UNITED STATES ENVIRONMENTAL PROTECTION AGENCY
REGION 2
290 BROADWAY
NEW YORK, NY 10007-1866

Re: EPA Reconnaissance Inspection December 19, 2018
Faztec Industries, Chelsea Road, Staten Island, NY
EPA NPDES No. NYU009854

UNITED STATES ENVIRONMENTAL PROTECTION AGENCY
REGION 2, DECA-WCB
290 Broadway, 20th Floor, New York, NY 10007

Program: Industrial Stormwater	**Inspection Type:** Compliance Evaluation Inspection
Permittee Name: Faztec Inndustries	**NPDES/ICIS No.:** NYU009854
Inspection Entry Date: December 19, 2018 **Inspection Entry Time:** 2:50 PM	**Inspection Exit Date:** December 19, 2018 **Inspection Exit Time:** 3:10PM
Facility Information: Faztec Industires, 200 Bloomfiled Ave. Staten Island, NY 10314 Or 331 Edward Curry Avenue, SI NY 10314	**Lat, Long:** 40.611546°, -74.186653° **NAICS / SIC Code:** Primary SIC Code 5032, Brick, Stone, and Related Construction Materials
EPA Representative(s): Murray Lantner, P.E. Environmental Engineer, EPA Region 2, DECA-WCB. (212) 637-3976	
State Representative(s): None	
On-Site Facility Representative(s): Steve Falcone, General Manager, Faztec Industries, 718 494 1600	
Responsible Official: Steve Falcone, General Manager, Faztec Indust

DSCN6305 – Entrance to Faztec Industries on Bloomfield Ave.
Hose running (for truck wheel wash/road washdown)
creating ponding on bloomfield Ave.

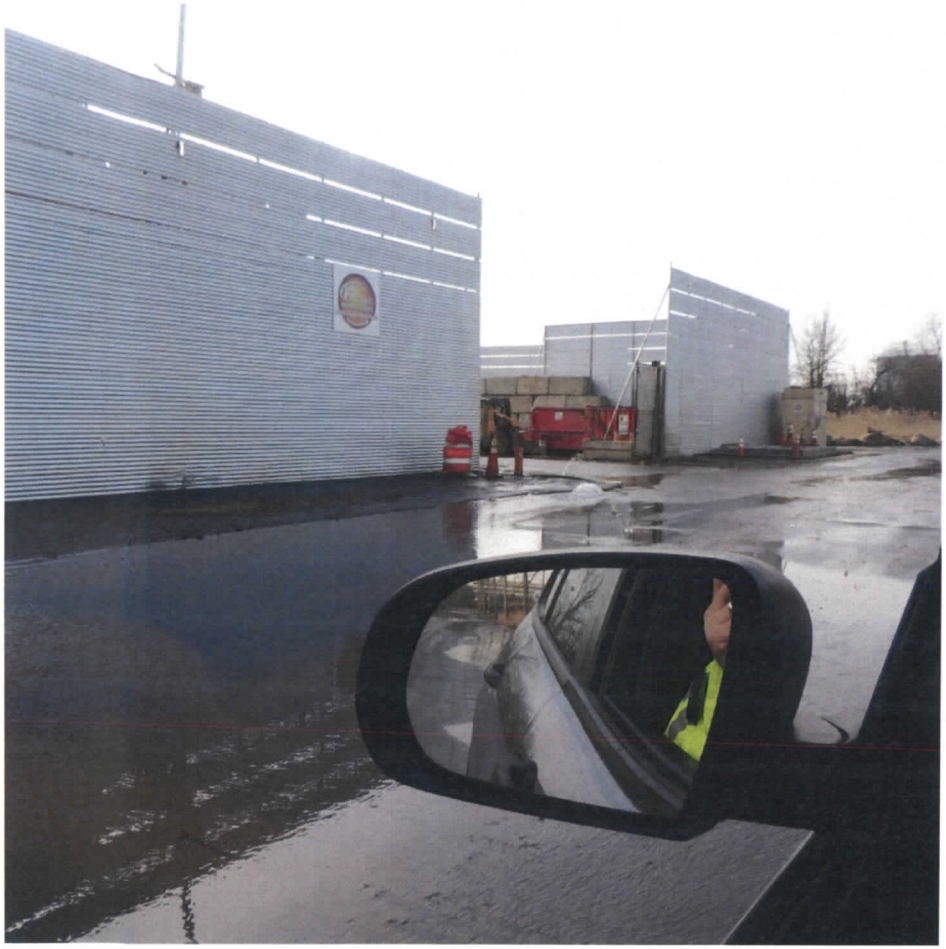
3. As shown in the photos 305 to 307, there was wheel wash water/dust suppression water flowing onto Bloomfield Avenue from the Facility. Facility should consider reducing its water discharges when not needed for dust suppression and road wash.

DSCN6306 - Entrance to Faztec Industries on Bloomfield Ave.
Hose running (for truck wheel wash/road washdown)
creating ponding on bloomfield Ave.

DSCN6307 - Entrance to Faztec Industries on Bloomfield Ave.
Hose running (for truck wheel wash/road washdown)
creating ponding on bloomfield Ave.
